**Freightliner  
Service Bulletin**

The design of the lift channel on the Coronado door window glass assembly has changed. The new lift channel has four studs, and older channels have three; see [Fig. 1](#). The design of the lift channel bracket on the regulator assembly has likewise changed to accommodate the extra stud.

**Fig. 1, Window Lift Channel Comparison**

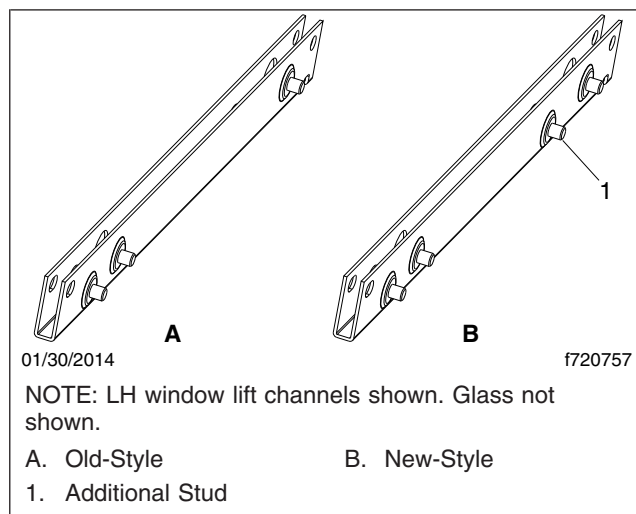
If both the window glass assembly and the regulator assembly are replaced, no modifications are needed. If a new window glass assembly is to be used with an old-style regulator, the forward lift channel bracket of the regulator must be modified as described in this bulletin.

**Fig. 2, Glass Lift Channel**

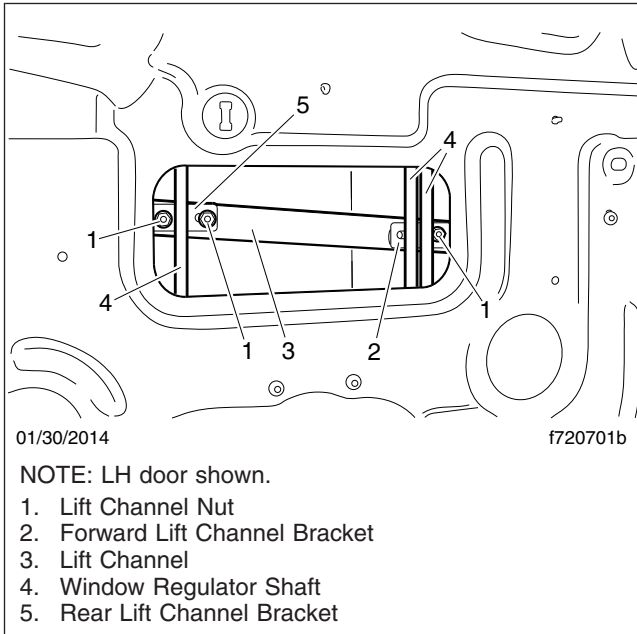
3. Remove the broken window glass assembly; see *Coronado Workshop Manual*, **Section 72.00, Subject 120**.
4. Make sure the lift channel is visible in the central opening of the inner door panel, as shown in [Fig. 2](#).

**Fig. 3, Slotting the Forward Lift Channel Bracket**

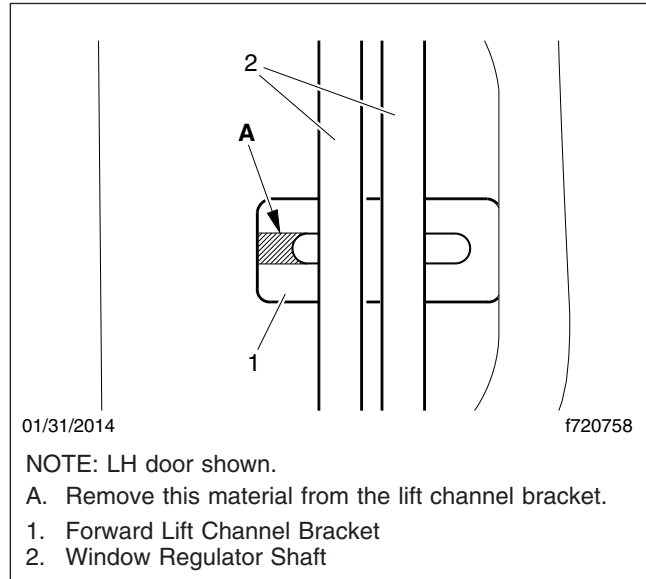
5. Grind a slot in the forward lift channel bracket, as shown in [Fig. 3](#).

NOTE: Because of the extra stud, an additional M6 nut (23-12828-006) is needed to attach the lift channel to the forward lift channel bracket.
